AERONAUTICAL SYSTEMS DIV WRIGHT-PATTERSON AFB OHIO
CRITICAL DESIGN REVIEW UH-1N HELICOPTER RESCUE HOIST.(U)
JUL 73 M H REAGAN, P P EODICE, D B DAY
ASD-TR-73-25

**CRITICAL DESIGN REVIEW
UH-1N HELICOPTER RESCUE HOIST**

TECHNICAL REPORT ASD-TR-73-25

This technical report presents the findings and recommendations resulting from the design review. The review covers work conducted from August 1972 through January 1973.

UPPER WINCH MOUNT

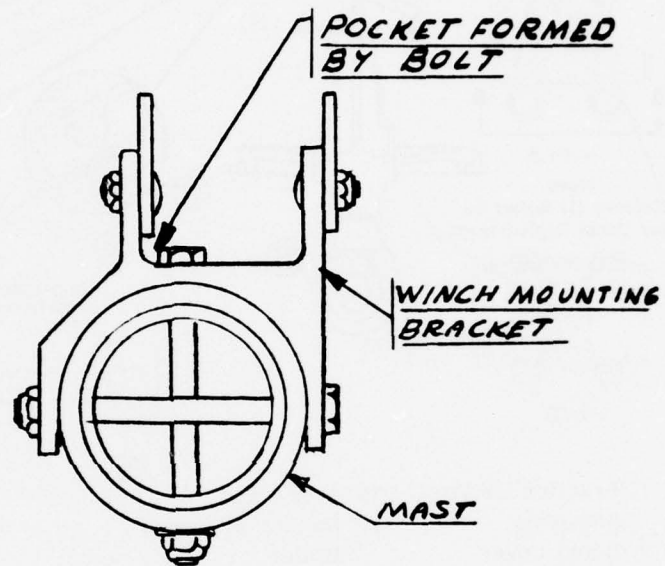
(4) Winch-to-Mast Connection - The brackets which facilitate mounting the winch on the vertical mast have been analyzed and found to be structurally adequate. It was determined, however, that a potential cable snag area is formed by a hex head bolt in the top mounting bracket (Fig 2). This condition can be corrected by substitution of an oval head machine screw.

(9) Upper Winch Mount - Replace the hex head bolt in the upper winch mount with an oval head machine screw to eliminate a pocket for potential cable fouling (Fig 2).

SECONDARY CAPSTAN (SECTION)

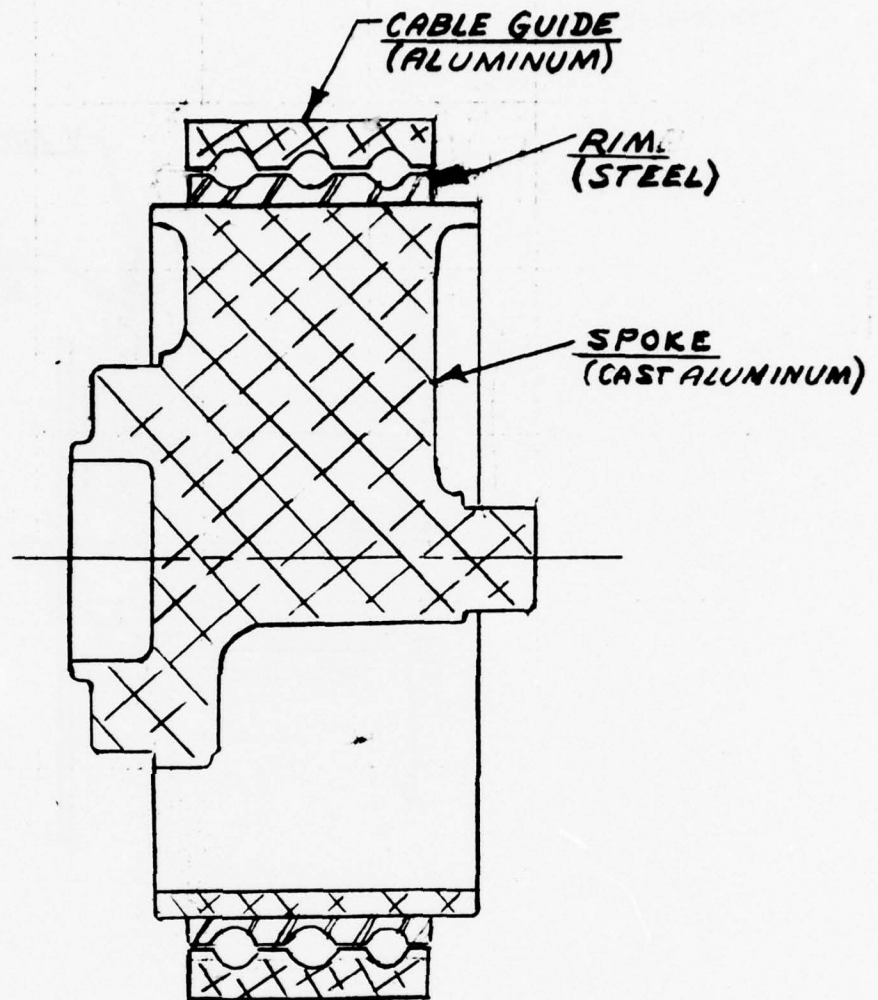
(c) Corrective Design Change - The in-house review team and Breeze Corp analyzed the failures described in (a) and (b) above. The out-of-tolerance condition was considered a possible cause for the lateral rim slippage but was discounted as a reason for spoke failure. Excessive winch bearing mount deflection was also considered as a potential cause of both the spoke failure and the rim slippage. This consideration was based on the fact that original winch qualification (endurance cycling at high load) was conducted at Breeze Corp with the winch mounted on a relatively massive test fixture. The CDR testing was conducted with the winch mounted on the relatively flexible mast. It was agreed that verification of such a theory would require additional extensive testing. The correction that appeared most promising was incorporation of a steel capstan of heavier section than the present cast aluminum/steel design.

(2) Secondary Capstan - Incorporate a steel secondary capstan in the winch to replace the existing aluminum and steel unit (Breeze P/N BL-5164). Configure the grooved surface so that the need for a side spacer (P/N BL-8079) is eliminated.

STORAGE DRUM CLUTCH SEAL (SECTION)

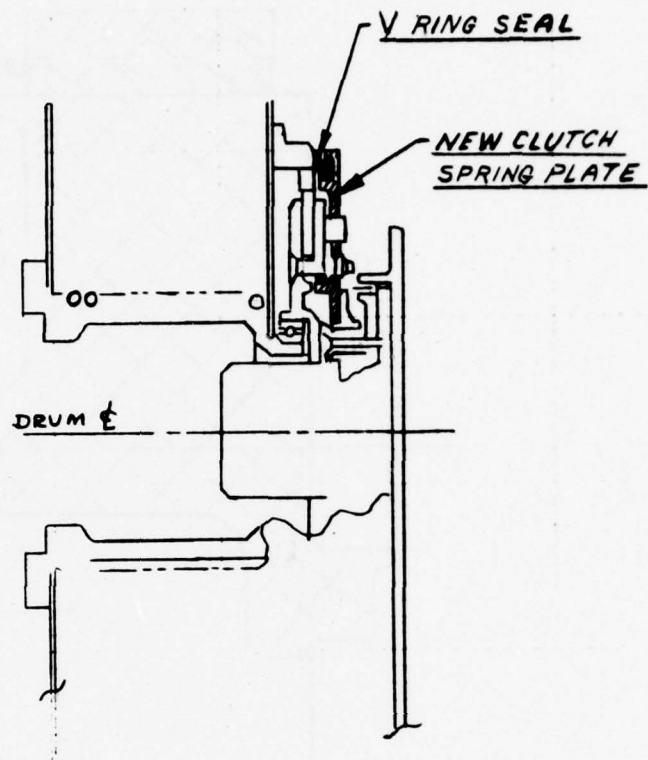
(a) Cable Spooling - When foreign material, such as water or grease, infiltrate the clutch area, the tensioning function of the clutch deteriorates to the point where the cable spools on the storage drum. This spooled cable can, and does, loop over the drum flange and fouls/binds when cable is subsequently payed out. This binding action creates excessive tension which finally severs the cable. Entry of foreign material can be stopped by installing a permanent clutch area seal (Fig 4).

SPACER TO PREVENT MISREEVING

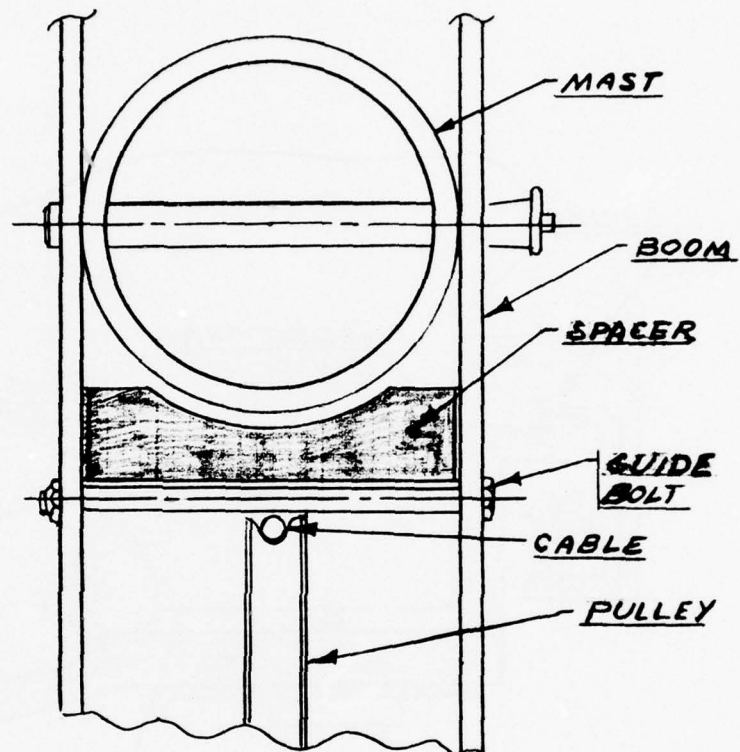
(2) Pulley - Although smaller than recommended by cable manufacturers for optimum cable life, the inboard boom pulley (Fig 1, item 28) is considered adequate in structure and cable interface. The adequacy is, however, dependent on cable replacement within prescribed intervals. With regard to installing a new cable on the hoist, there is a configuration in this area that has led to a misreeved and subsequently failed cable. The cable guide bolt (Fig 1, item 34) is located so that cable can be reeved over the bolt rather than properly between the bolt and pulley. The potential for misreeving could be greatly reduced by incorporating a spacer to block out the area between the bolt and the mast. The area in question and spacer configuration are schematically depicted in Fig 5.

UP LIMIT SWITCH

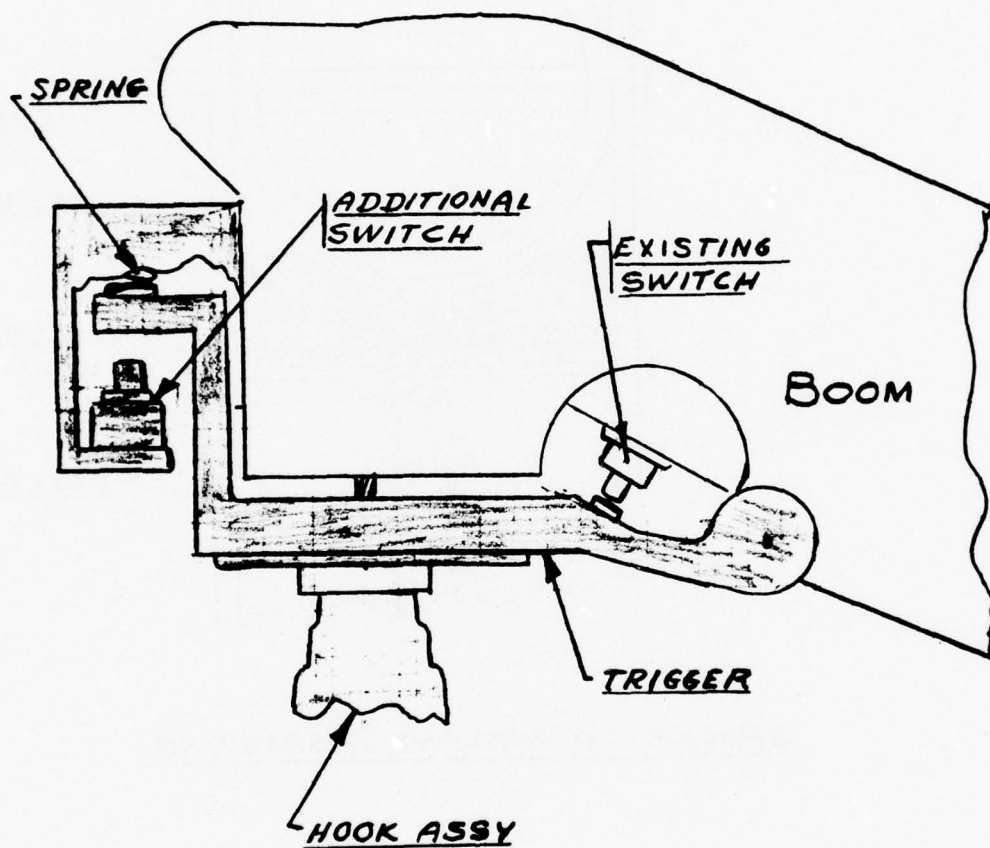
(c) Corrective Design Change - Considering the above, it is apparent that a rather extensive up limit switch assembly redesign is required to insure near fail safe performance. A design of this type would incorporate full redundant electrical circuitry, would not be adjustable in the field, and would have rugged construction to resist deformation. One such design is schematically depicted in Fig 6.

(1) Hoist Up-Limit Switch - Redesign the hoist up limit switch to provide partial mechanical, and full electrical, redundancy (including the control box power relay), to eliminate field adjustment, and to provide more structural integrity. See Fig 6 for a schematic depiction of design features and Section II for rationale.

ANTI COCKING DEVICE

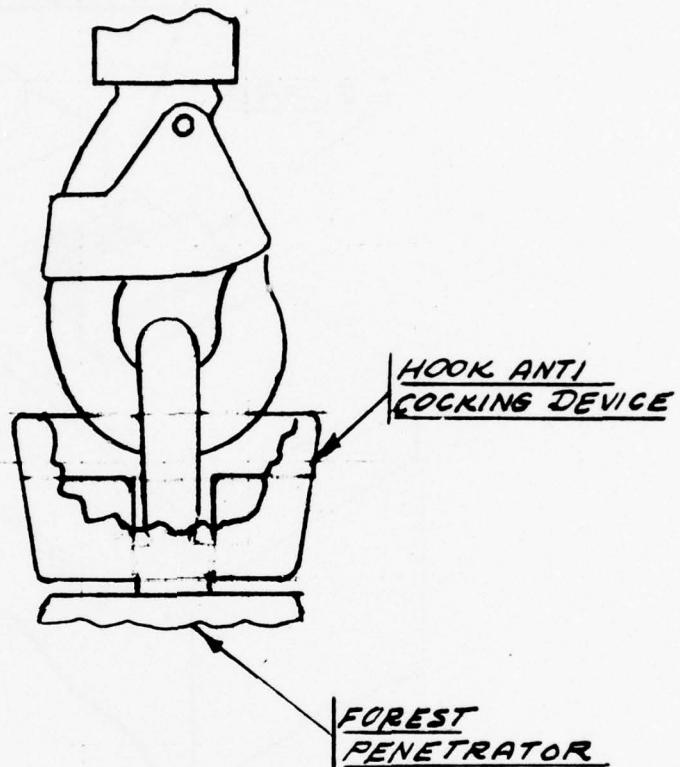
(7) Hook Anti-Cocking Device - Provide hook anti-cocking devices for use with the forest penetrator (Fig 7). This device will reduce an adverse cable loading condition caused by a sharp bend at the ball end fitting.

GUILLLOTINE SWITCH GUARD

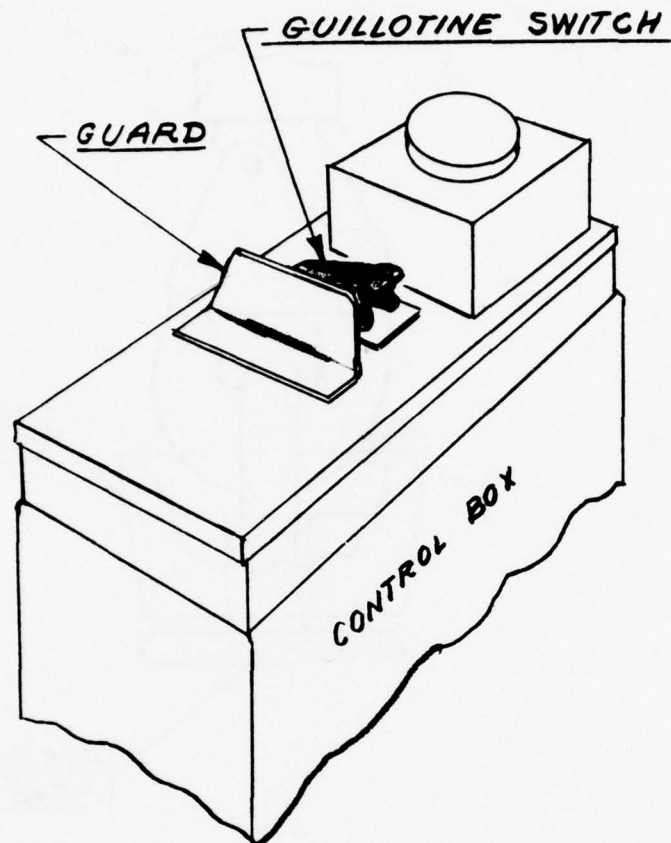
(4) Guillotine Switch - Add a guillotine switch guard as generally depicted in Fig 8 to protect against inadvertent operation.
